**Nature Reserves Preservation Group
of Kalamunda, Inc.**

SUBJECT: Submission on South32 Worsley Alumina's proposed 'Worsley Mine Expansion'

*Graph: "Radiative forcing of a 1kg pulse emission of methane and carbon dioxide over time" <https://pubs.rsc.org/en/content/articlehtml/2018/em/c8em00414e>

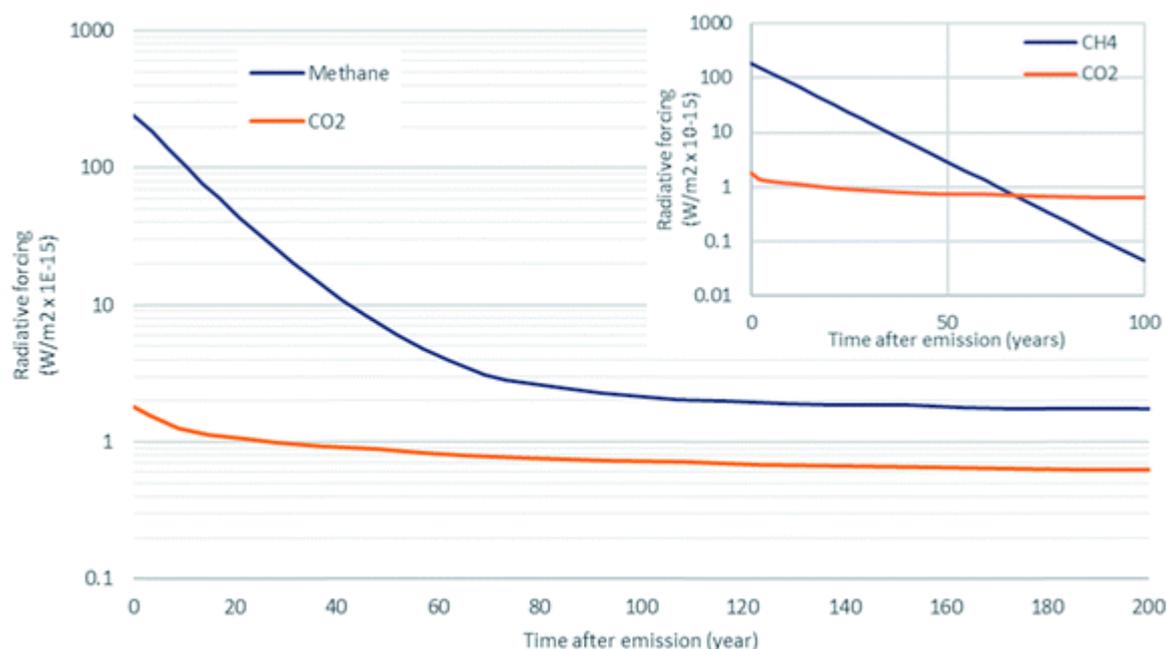
This planned switch from coal to gas it claims will reduce South32 Worsley's operational CO₂ emissions but ignores the extremely high Global Warming Potential (GWP) of methane emissions from gas production.

*It should be noted that 'Natural gas' (commonly called 'gas'), is methane, and while it is often claimed as being 'clean', it has two serious problems:

- It is a fossil fuel (unless from biomass) and is generally used very inefficiently when burned, plus it emits toxic by-products.
- It is a very powerful Greenhouse gas (GHG) with a Global Warming Potential (GWP) equivalent to 84-100+ times that of CO₂, in the most critical near-term period of 20 years. (Ref: R.W. Howarth advised on methane portions of New York's climate law. 2019 [cited 2019 31 August]; Available from: <http://news.cornell.edu/stories/2019/07/howarth-advised-methane-portions-nys-new-climate-law>, and: "Methane emissions: choosing the right climate metric and time horizon" <https://pubs.rsc.org/en/content/articlehtml/2018/em/c8em00414e>). As such it can cause high global warming effects even from very small leakage and venting between the source through the supply chain to point of combustion, (or by anaerobic decomposition of waste or biomass). For example, gas leakage of just 2-3% in the supply chain can make it as bad, or worse, than burning coal for electricity generation.
